SUNDRY NOTICES AND REPORTS ON WELLS (DO NOT USE THIS FORM FOR PROPOSALS TO DRILL OR TO DEEPEN OR PLUG BACK TO A DIFFERENT RESERVOIR. USE "APPLICATION FOR PERMIT" (FORM C-101) FOR SUCH PROPOSALS.)		WELL API NO. 30-025-45320
1. Type of Well: Oil Well ☒ Gas Well ☐ Other ☐		5. Indicate Type of Lease STATE ☒ FEE ☐
2. Name of Operator EOG Resources, Inc.		6. State Oil & Gas Lease No.
3. Address of Operator P.O. Box 2267, Midland, Texas 79702		7. Lease Name or Unit Agreement Name Mamba 30 State Com
4. Well Location Unit Letter <u>M</u> : <u>711</u> feet from the <u>South</u> line and <u>607</u> feet from the West <u>line</u> Section <u>30</u> <u>24S</u> Township <u>33E</u> Range <u>NMNM</u> Lea <u>County</u>		8. Well Number 708H
11. Elevation (Show whether DR, RKB, RT, GR, etc.) 3556'		9. OGRID Number 7377
		10. Pool name or Wildcat WC-025 G-09 S243361; Upper Wolfcamp

EOG Resources Inc, respectfully requests to amend the APD (Permit 257952) to change the bottom hole location for the above referenced well. Attached please find the following amended documents: C-102 plat, the proposed wellbore diagram & the proposed drilling/casing/cementing/mud information.

Permit Information Revised 1/1

**Revised Wellbore Design A
1/15/19
API: 30-025-45320**

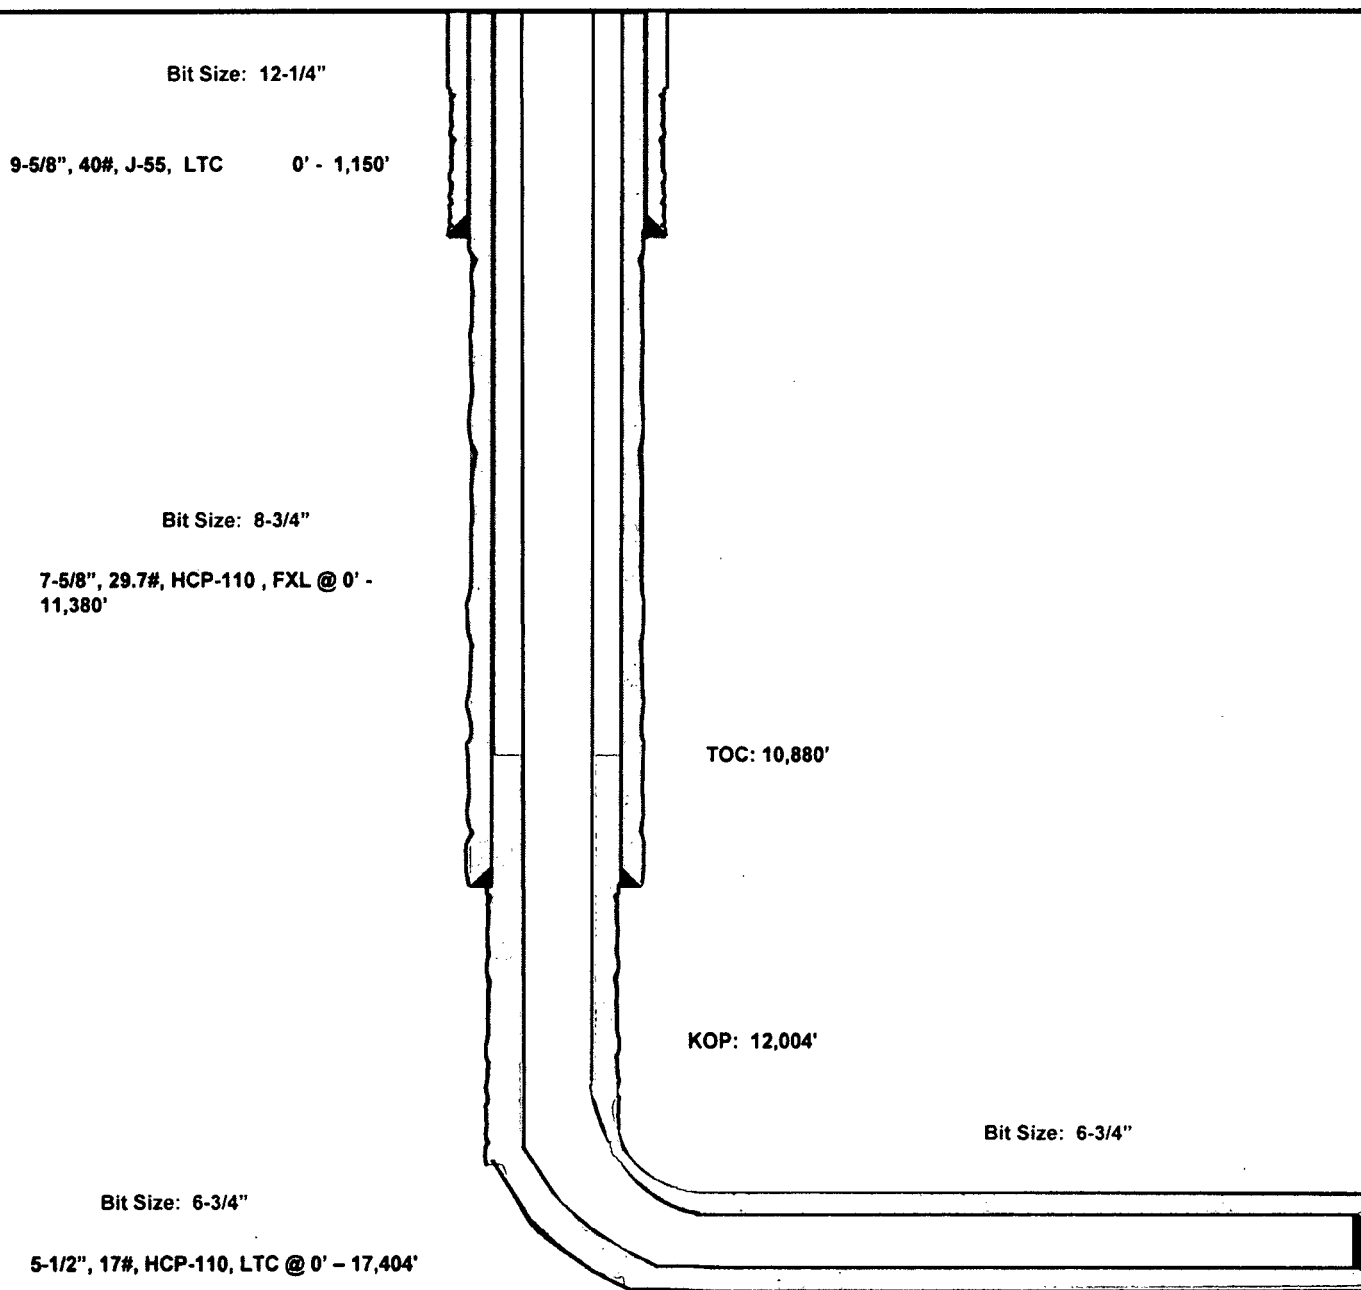
BHL: 100' FNL & 330' FWL, Section 30, T-24-S, R-33-E, Lea Co., N.M.

Lateral: 17,404' MD, 12,452' TVD

**BH Location: 100' FNL & 330' FWL
Section 30
T-24-S, R-33-E**
